**CITY OF TEMPE
DEVELOPMENT REVIEW COMMISSION**

**Meeting Date: 02/11/2014
Agenda Item: 4**

ACTION: Request for a Use Permit to allow Tandem Parking and a Development Plan Review consisting of a new 33 unit multi-family development for JENTILLY LANE CONDOMINIUMS, located at 1717 South Jen Tilly Lane. The applicant is Trapezium Consulting.

Jentilly Lane Condominiums
1717 S Jentilly Lane
Site Plan

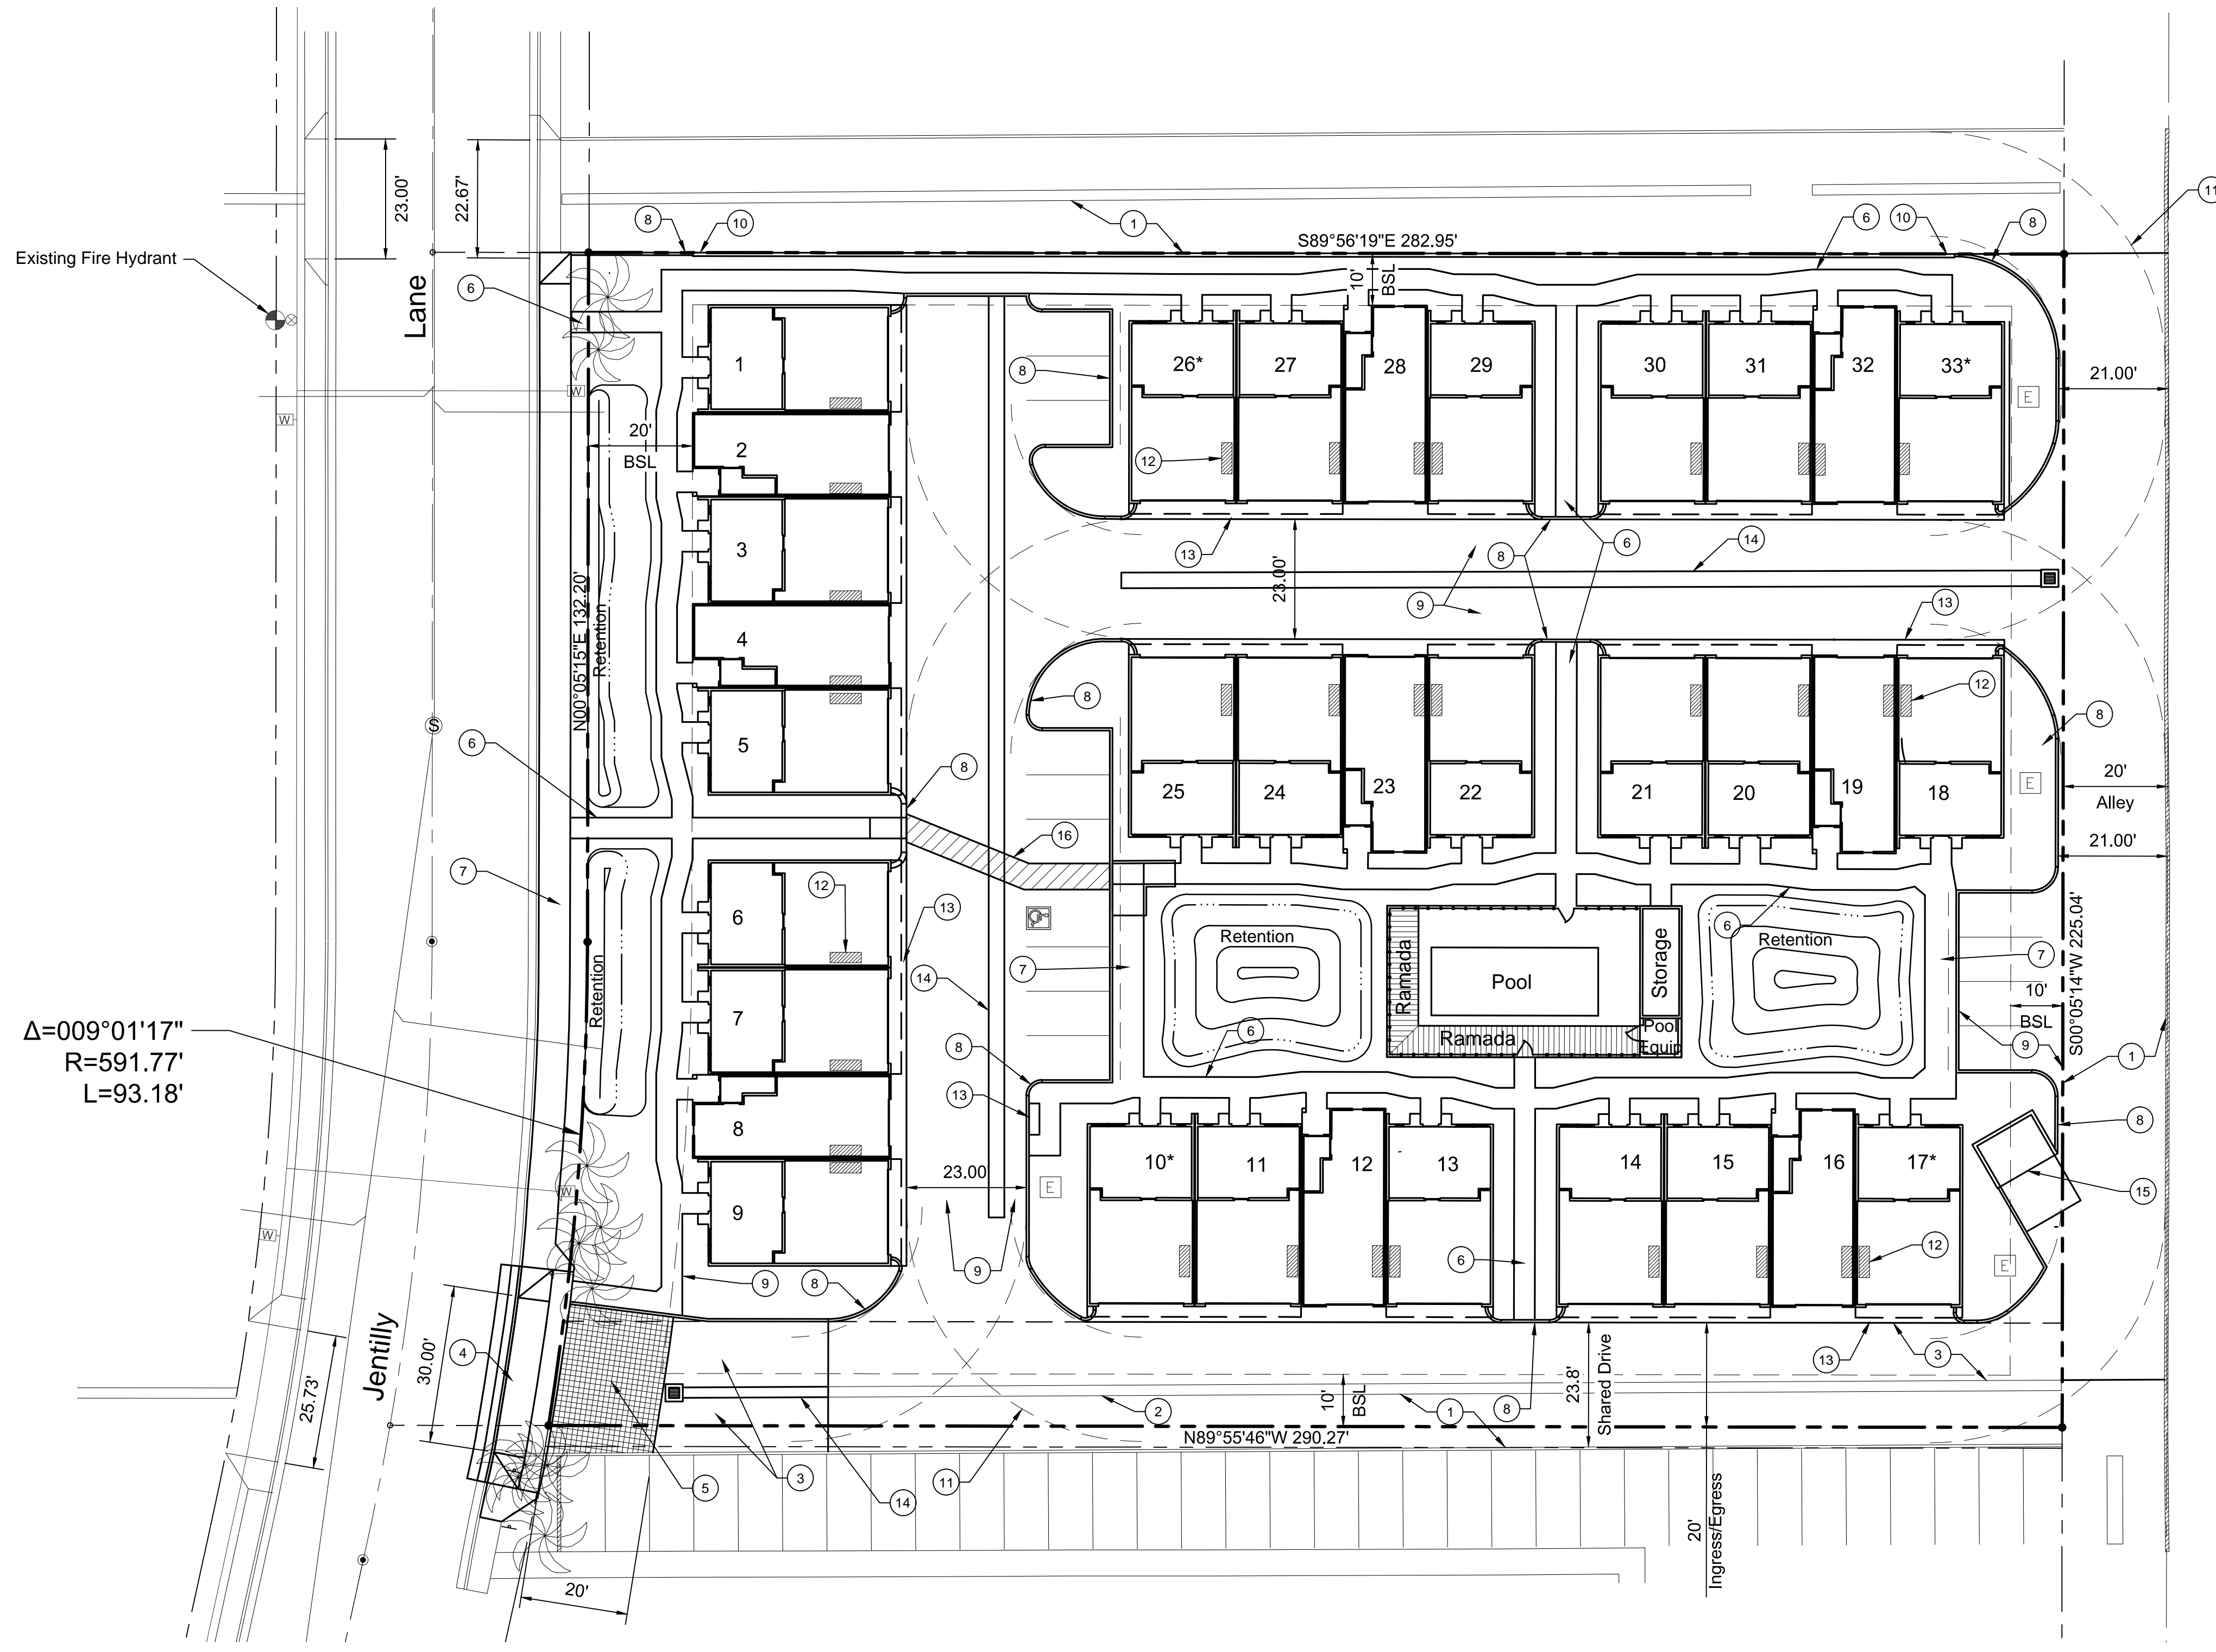
5. Provide upgraded paving at entire driveway consisting of clay or concrete unit paving. Detail unit paving to accept weight of emergency vehicles and turn action of full size vehicles maneuvering into the garages and the guest spaces. Provide unit paving of color that contrasts with the uncolored accessible concrete walkway pavement and compliments the color of the buildings. If possible, detail unit pavement to be porous to improve site water retention and potentially reduce heat retention.
6. Updated driveway entrance to be coordinated with the property located to the south in order to maintain access for existing parking spaces.

Plan 2 - 1,648 Sq. Ft. - 1,665 Sq Ft.

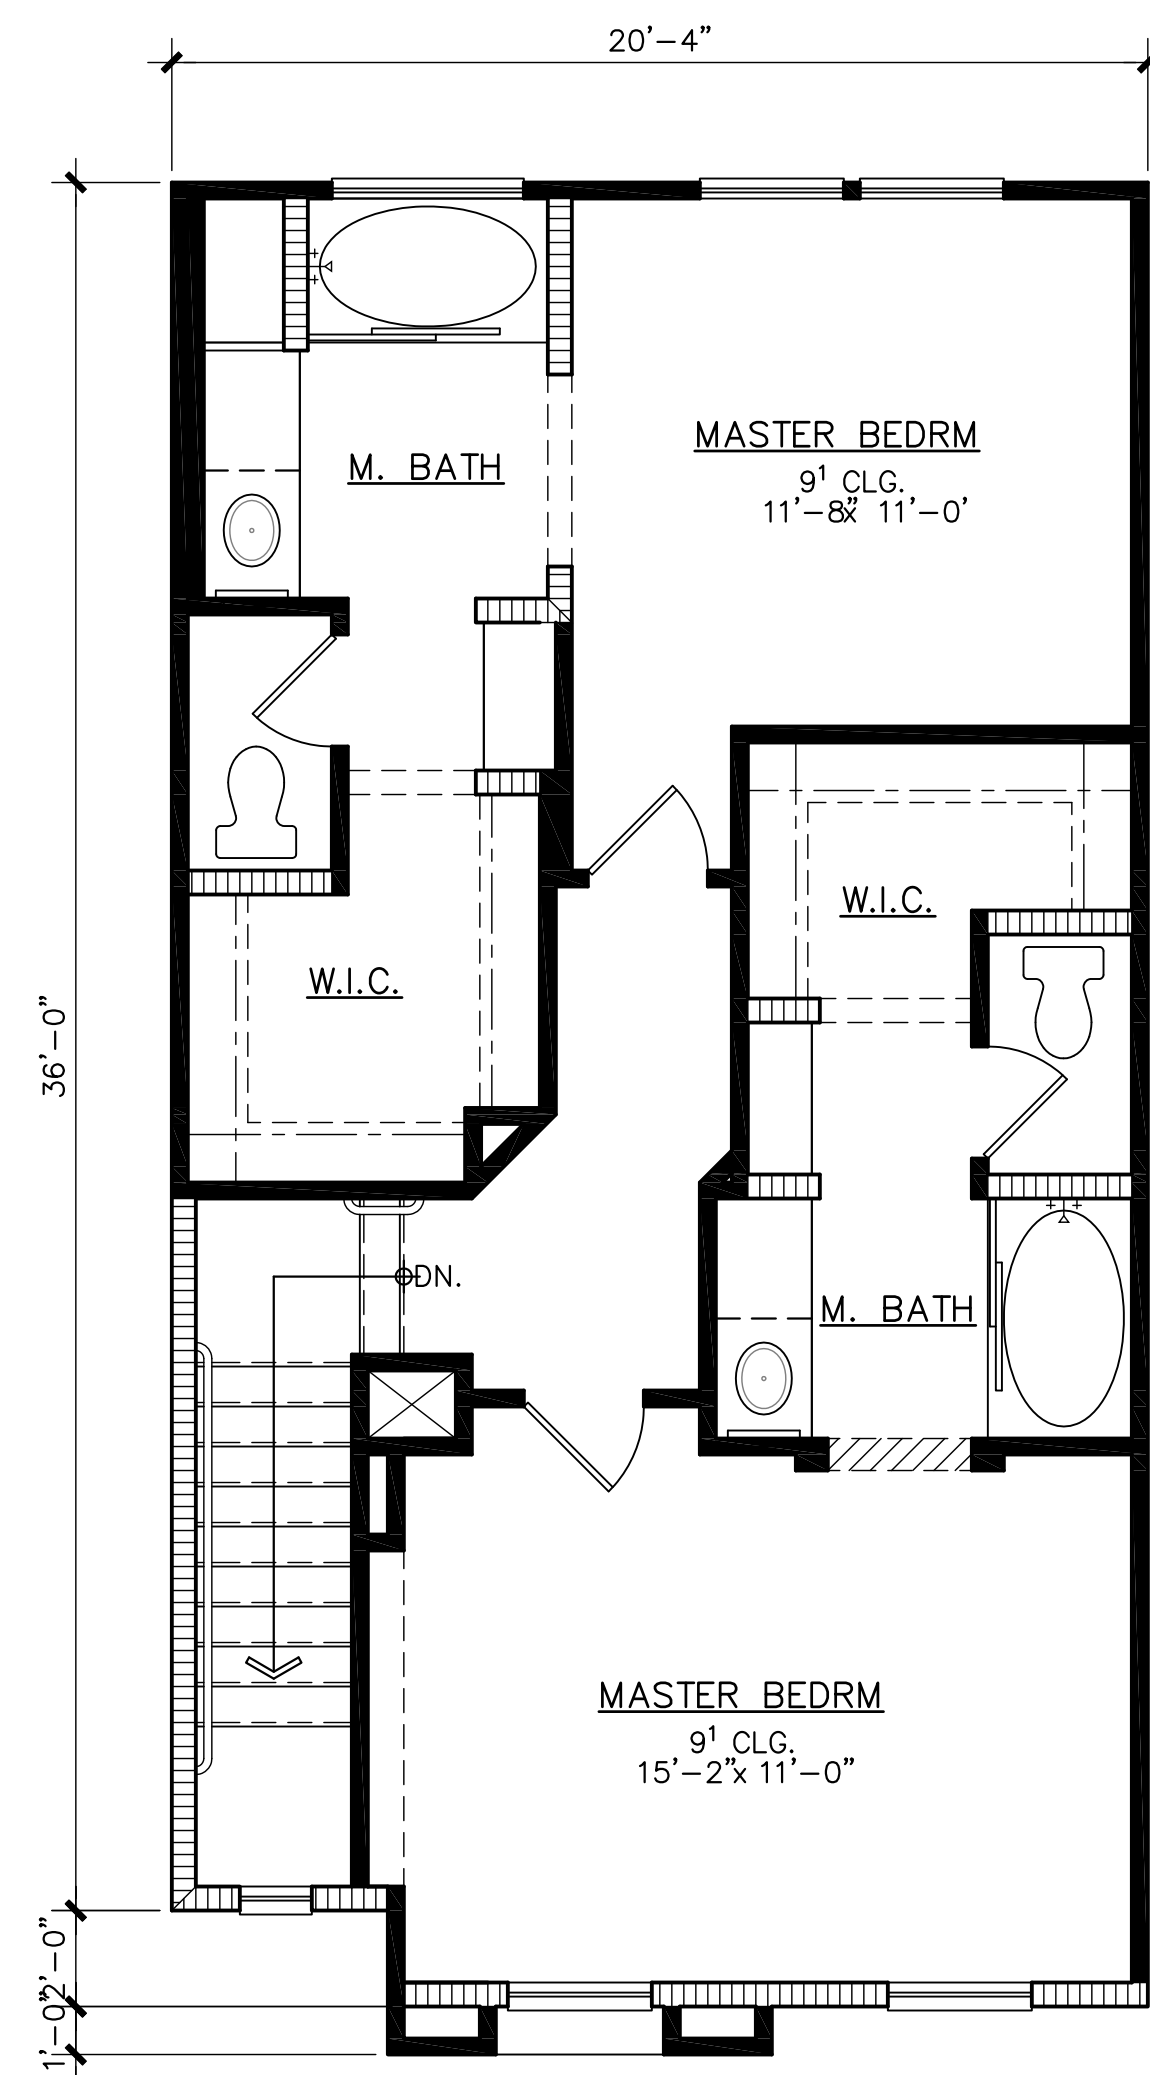
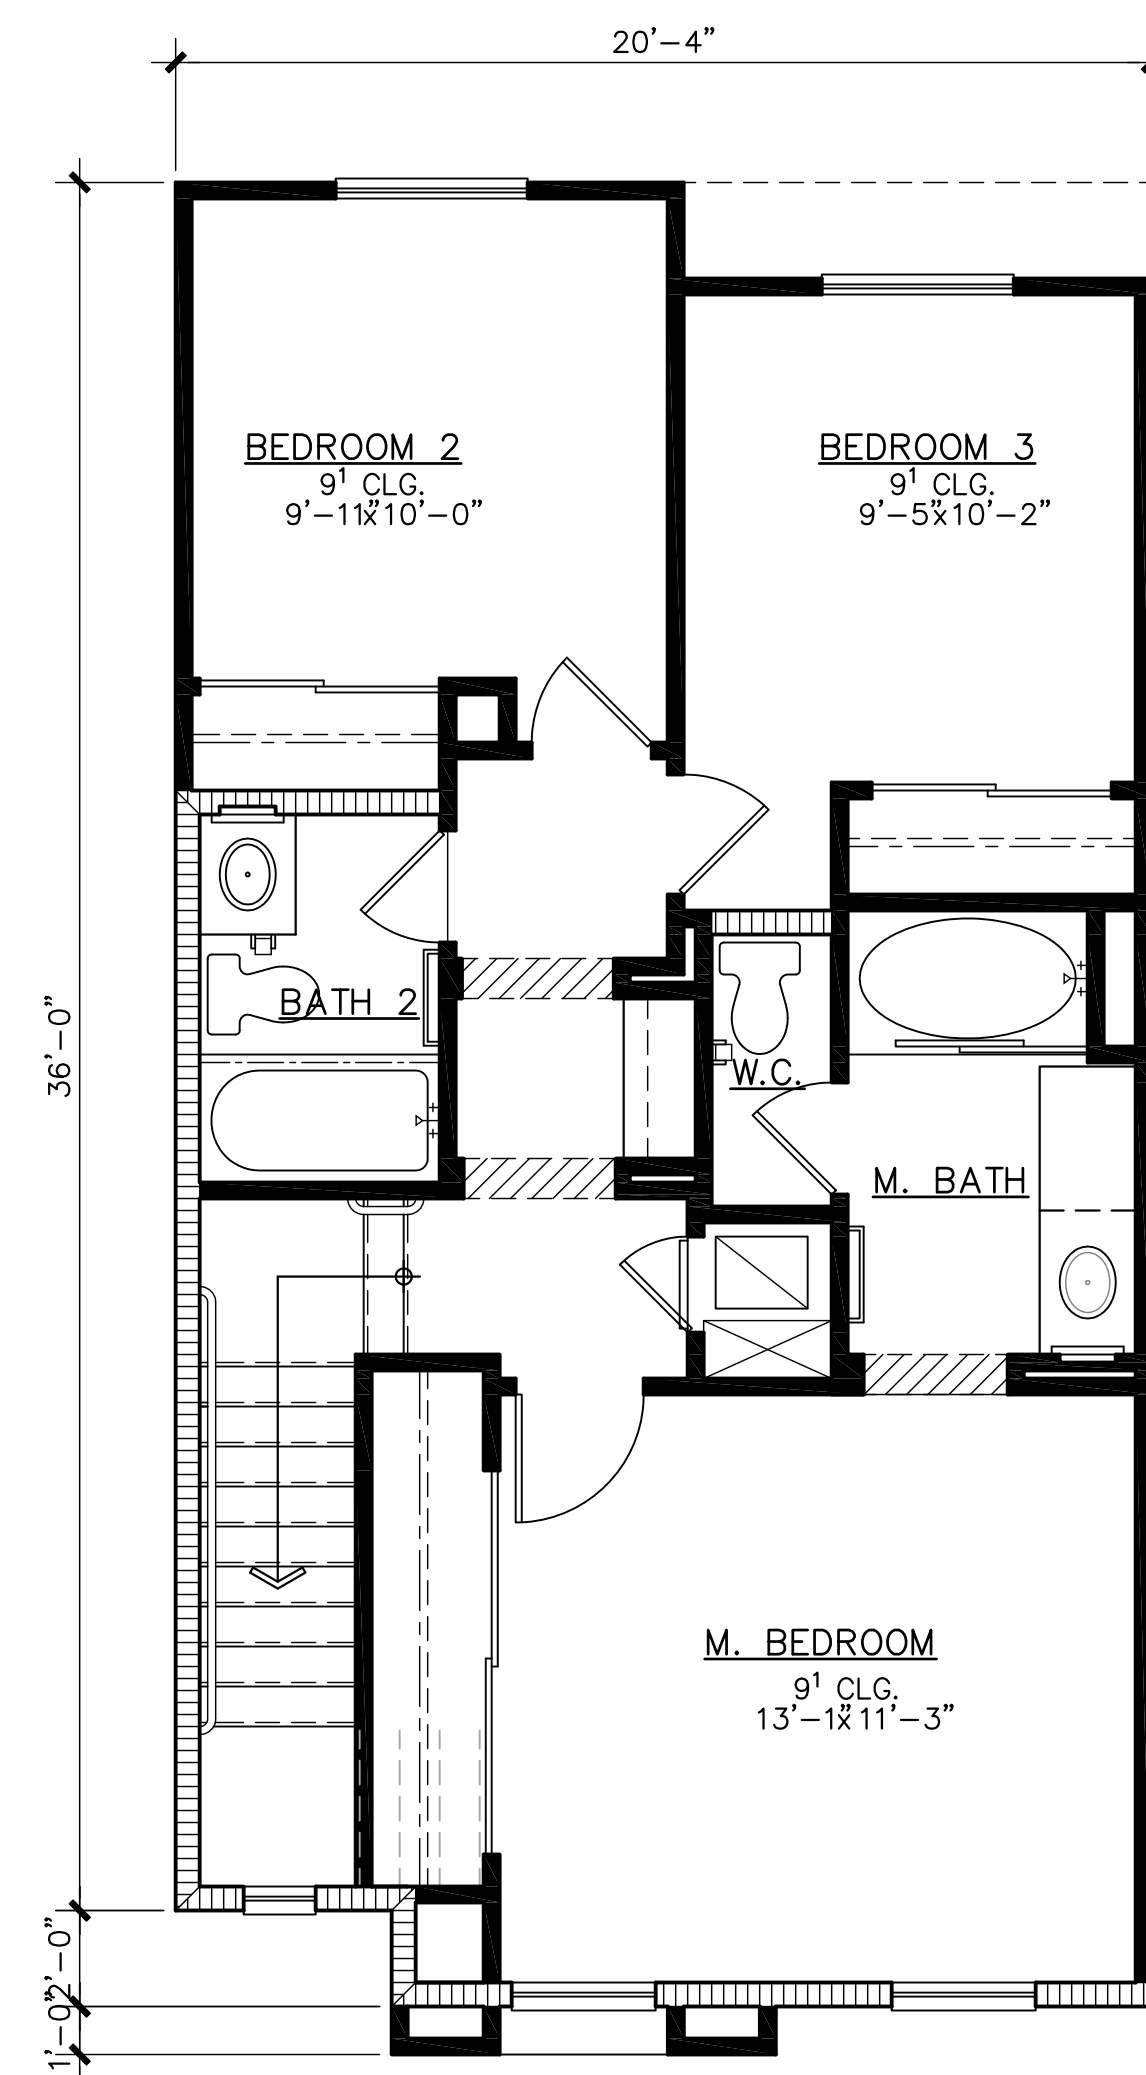
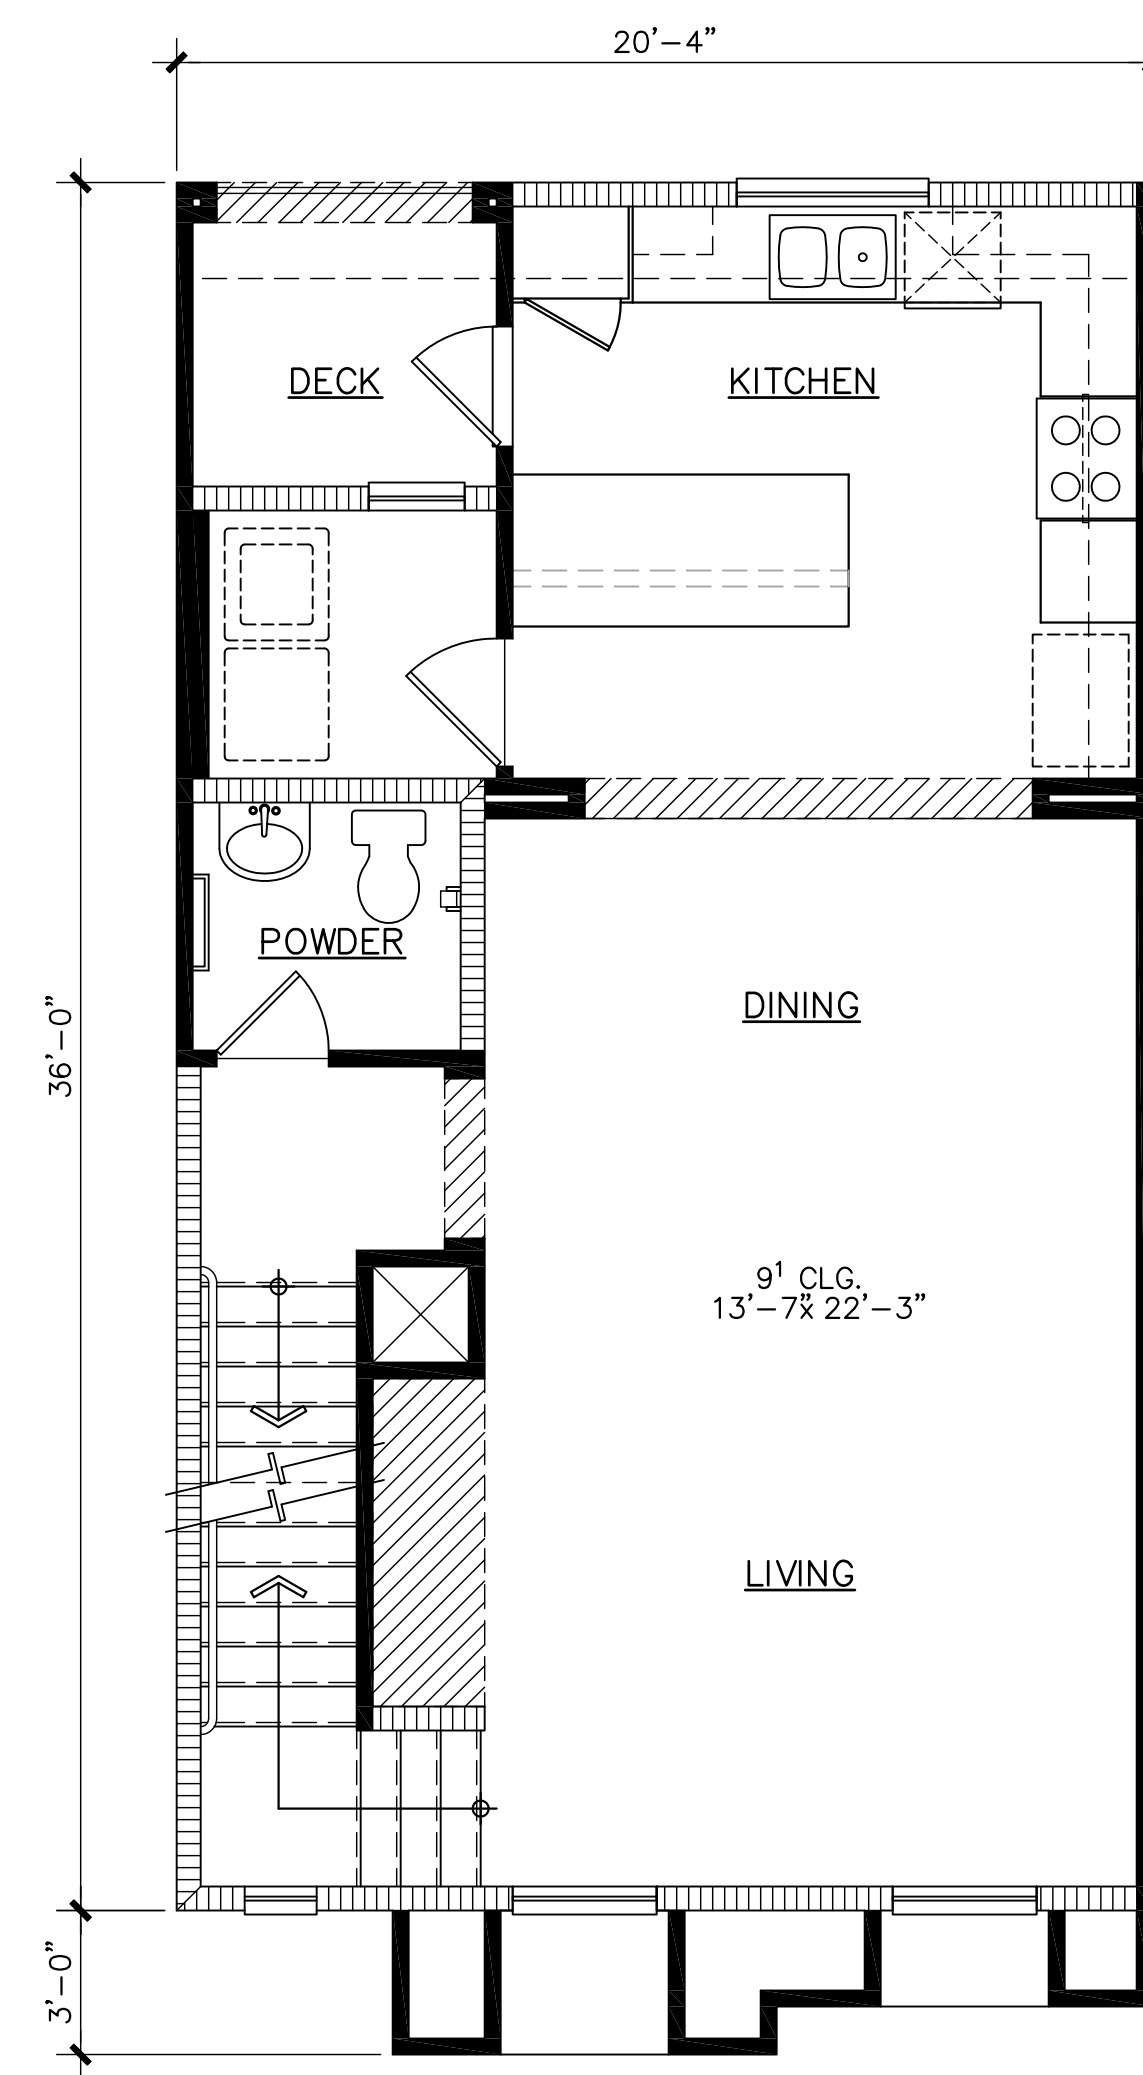
7. Flexible rooms shown on floor plans of Unit 2 designs shall be counted as bedrooms in the calculation of the required number of parking spaces.
